## Addendum to “Belmont Quarry – Hydrological analysis of proposed land exchange”

I am the author of the above report and have the qualifications and experience set out in the introduction of that report. I have been provided with comments received on the Belmont Land Exchange Application and have been asked to respond to those within my area of expertise. I confirm that I have adhered to the Environment Court’s Code of Practice for expert witnesses when preparing these comments.

**Figure 1: Figure 2.1 from the Hydrology Report updated to show the land exchange boundary and a potential OBDA, the design and construction of which will be addressed in a subsequent application.**

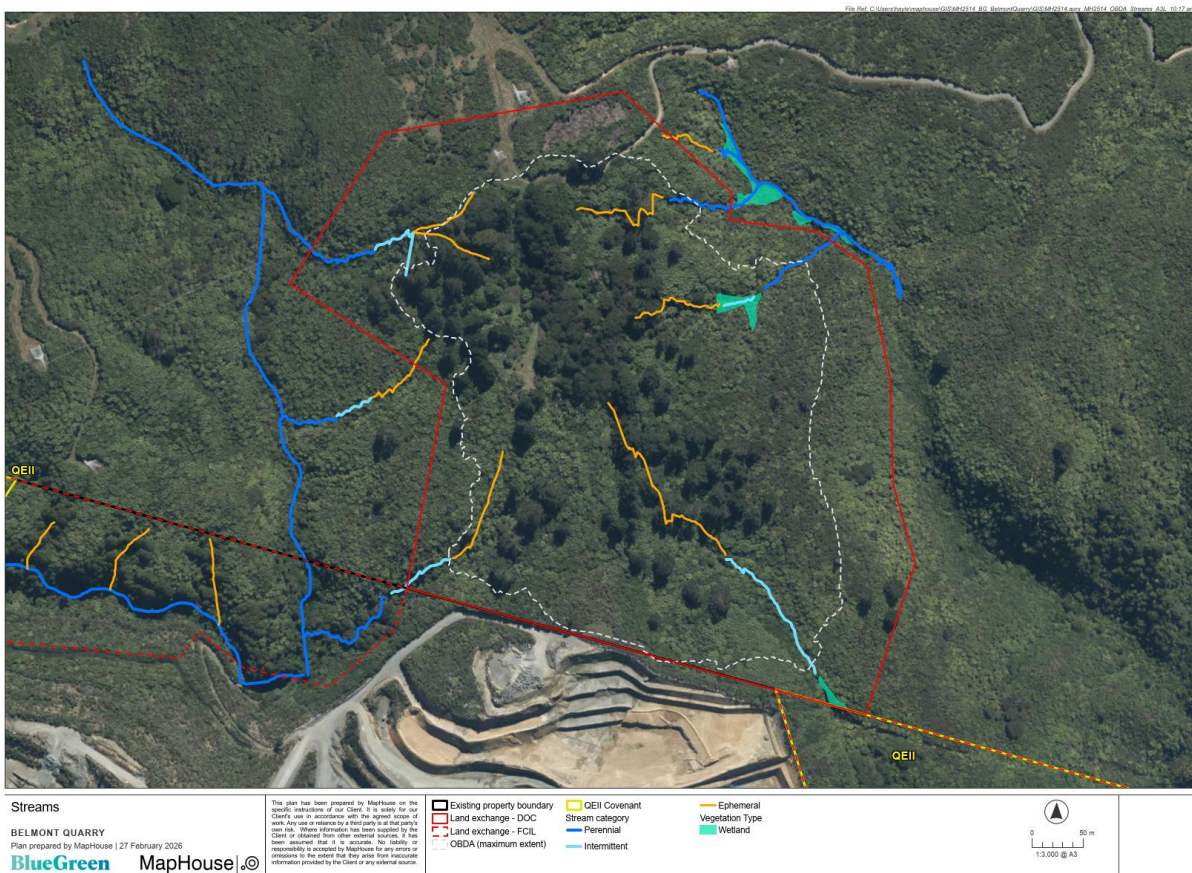
*The Hydrology assessment (Appendix B9) significantly underestimates the streams in the POBDA, and states that it contains no perennial streams, concluding that the proposed dumping of overburden would not affect the drainage characteristics of the area. In fact the POBDA contains streams that have never been seen to dry up in the last 20+ years, and the wetland ecology of the area would be destroyed.*

*In late 2025 the applicant revised the POBDA western boundary to exclude one population of swamp maire. The FoBRP regards this as a welcome but token adjustment since (see Fig 2.1 on p3 of the Hydrology Assessment) the watercourse upstream of the "excluded" swamp maire would still be buried in overburden. As J T Salmon points out (on p168 Native Trees of New Zealand): "if the swamp or bog is drained, the tree dies within one or two years". Regardless of the western boundary adjustment, the largest wetland and associated flora (upstream of the pond, in the south-east) would still be destroyed by the proposed overburden disposal.*

*The Hydrology assessment can be found in Appendix B9. It claims that the POBDA area only contains intermittent and ephemeral streams, ie, that there are no streams that flow continuously. This seems to be based to a large extent on what is depicted on the LINZ topographical maps, and Strahler stream order in combination with a digital terrain mode, rather than by repeated field observations. LINZ topographical maps are known to show watercourses where none exist (eg on karst landforms) and they are not intended to provide a reliable source of hydrological information.*

*Consequently the Hydrology assessment significantly undervalues the importance of the stream courses within the POBDA. In particular (p8) "The [LINZ's topographical map] shows no streams in this area (Figure 2.5). Consequently, there is likely to be only limited surface flow in the proposed OBDA. The existing rainfall-runoff relationships, and patterns and characteristics of drainage, will be retained during any land exchange". This is simply incorrect: members of FoBRP have been visiting the area over the past 20 years and have never seen a lack of flow in the stream that feeds the wetland supporting swamp maire and ramarama, upstream of the pond. These observations over a long period of time are unique to community members, and not something a desktop survey could hope to capture. **Perennial streams definitely exist within the POBDA, and they must be accounted for in the application.***

*After the initial discovery of 14 swamp maire within the POBDA, the applicant brought the western boundary eastwards in an attempt to mitigate the impact, ostensibly by avoiding the swamp maire. However the submitted plans (eg Fig 2.1 on p3 of the Hydrology Assessment) show the catchment upstream of these trees to be within the POBDA, and if the hydrology in this gully is modified, this grove of swamp maire could be expected to die within one or two years, as was explained in section 3 above.*

The Hydrology Report does not state that there are no perennial streams within the OBDA exchange area. Various reaches of the watercourses with perennial flow are mapped and shown in **Figure 1** above.

As shown in **Figure 1**, a significant buffer is proposed between any OBDA and the boundary of the exchange area. It is my expert opinion that it is possible to design an OBDA, with its associated drainage and sediment control, so that any effects on hydrological processes are less than minor at the boundary of the exchange area. There will be no measurable adverse effects on hydrology or hydrological processes beyond the boundary of the exchange area. The OBDA will not affect any wetlands or the flow regimes of any streams down-gradient of the OBDA.

The only wetland that will be adversely affected by the development of an OBDA is that located within the OBDA (**Figure 1**). As explained above, by applying the hydrological principles and practices from the existing Cottle's OBDA, the hydrology of the remaining wetlands will be unaffected by the development. The operation of the existing Cottle's OBDA proves that existing hydrological

This is incorrect as discussed in both the Hydrology Report and this addendum. The mapping of watercourses and drainage lines has used consistent, robust, industry-standard tools. Comparison of the hydrological attributes of the various exchange areas is therefore robust and accurate. Perennial streams have been mapped in the OBDA (**Figure 1**). The hydrological assessment was not reliant on what is shown on LINZ topographical maps.

There are some watercourses with perennial flow within the OBDA exchange area and these were marked on **Figure 1**. The nature and characteristics of streamflow generation, including both surface and subsurface flows, are discussed in detail above and in the Hydrology Report.
